PROJECT NUMBER ~~CD-4B~~ 1717

STREET & UTILITY IMPROVEMENTS

DURANES PAVING PROJECT

RECORD DRAWING
9/13/83 JH

TITLE: PAVING
CD-4B
LOS LUCEROS ROAD
STA. 0+00.00 TO STA. 11+00.00

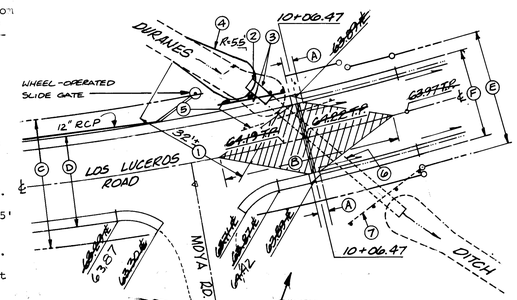
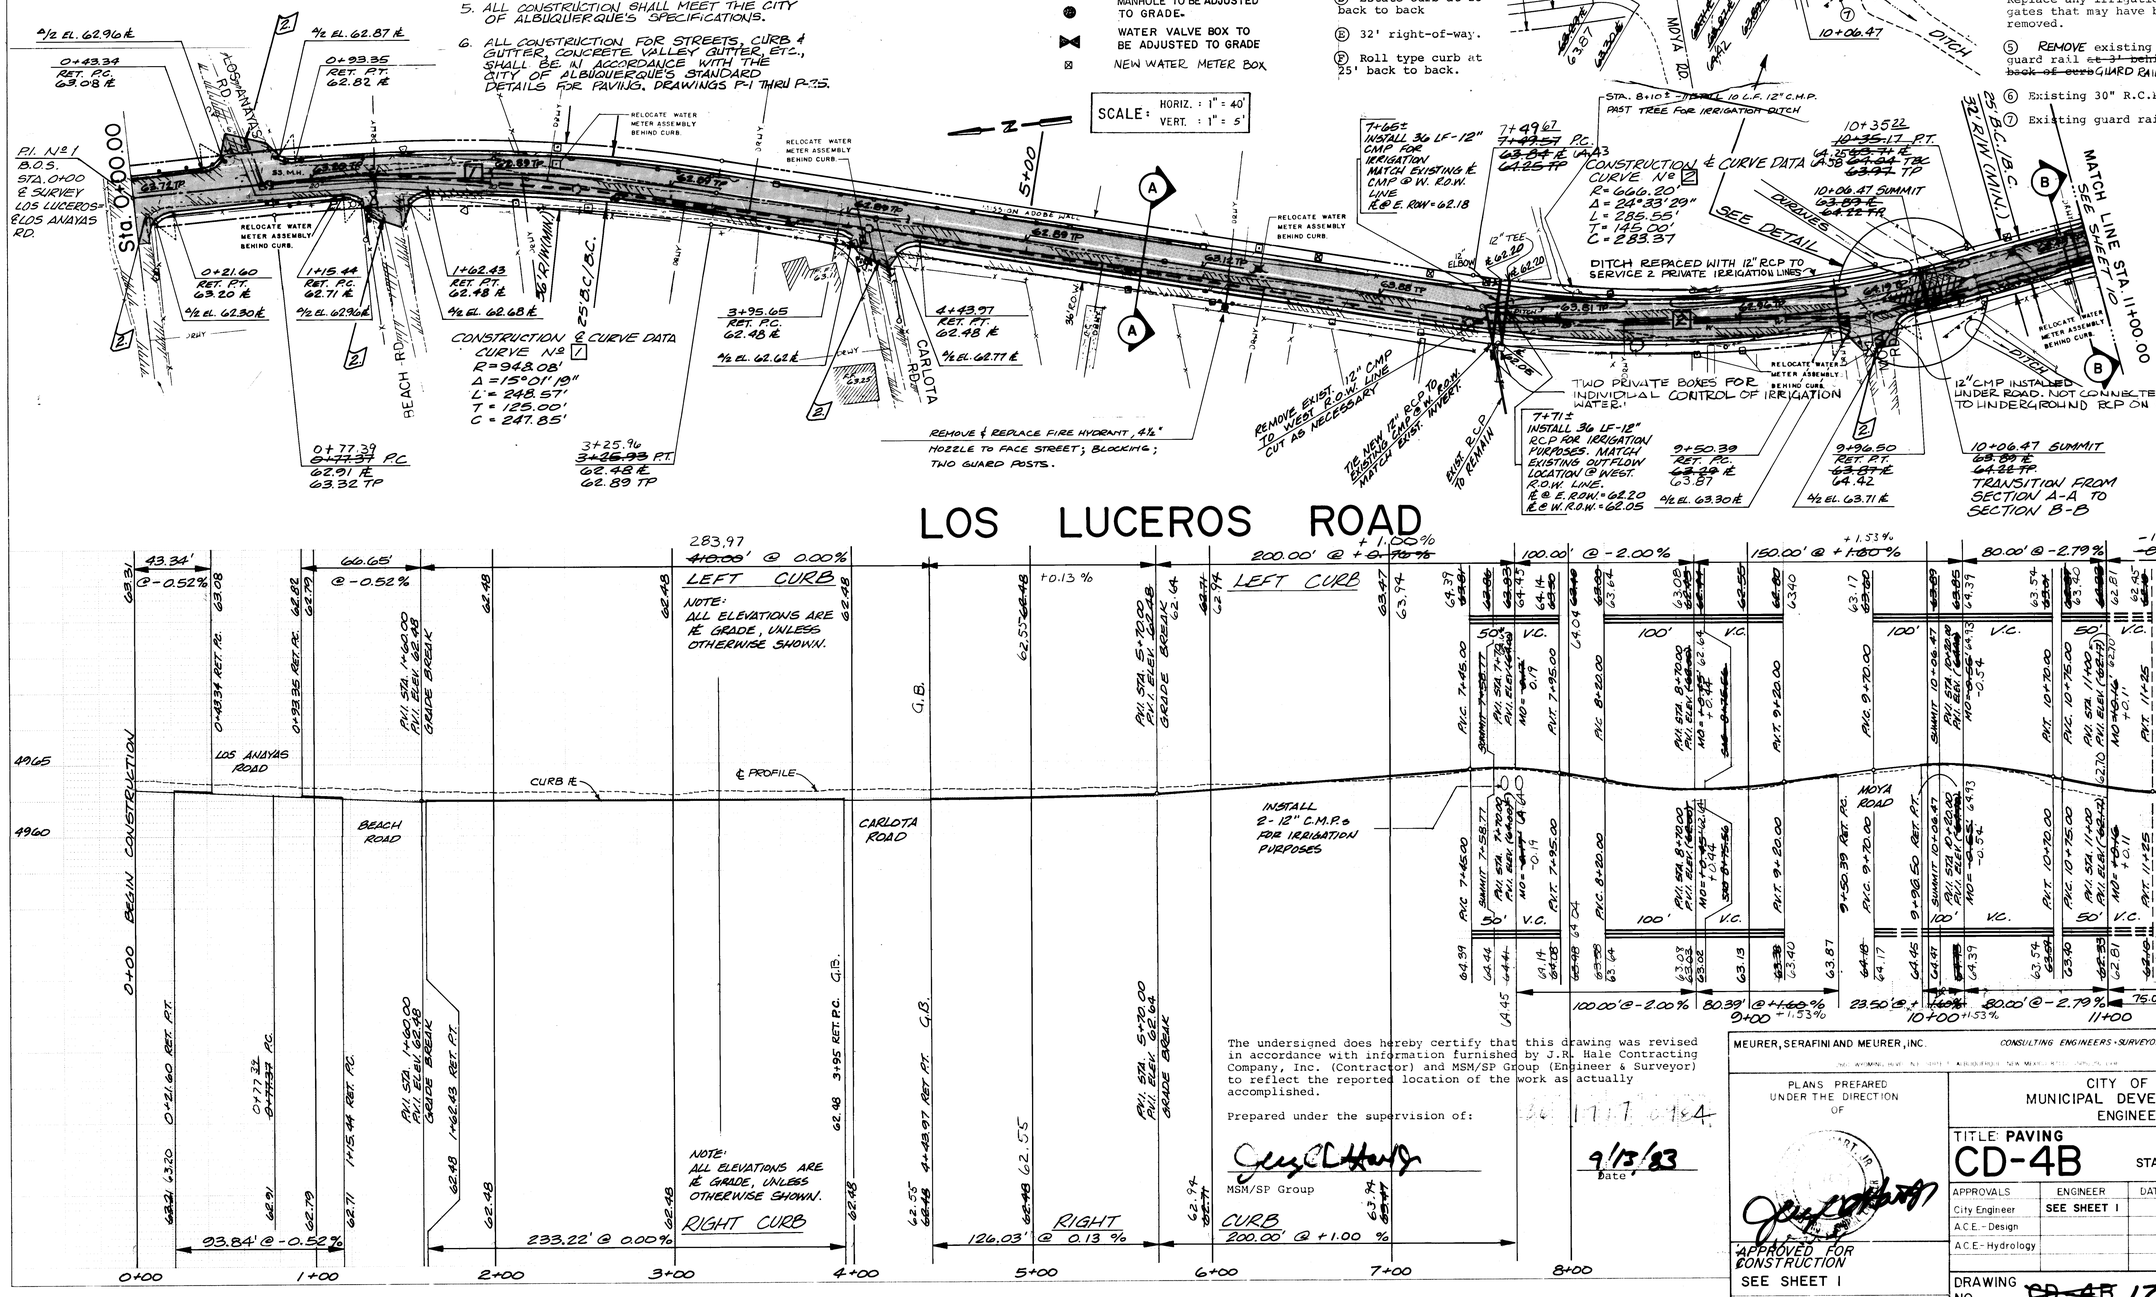
(5) REMOVE existing 25' guard rail ~~at 3' behind~~ 20 LF ~~back of curb~~ GUARD RAIL INTALLED

TYPICAL IRRIGATION DITCH
STA. 7+71 ± TO STA. 9+80 ±

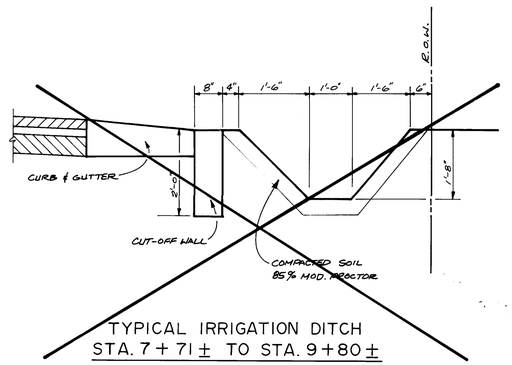
NOTE: DITCH DELETED. REPLACED WITH 12" RCP
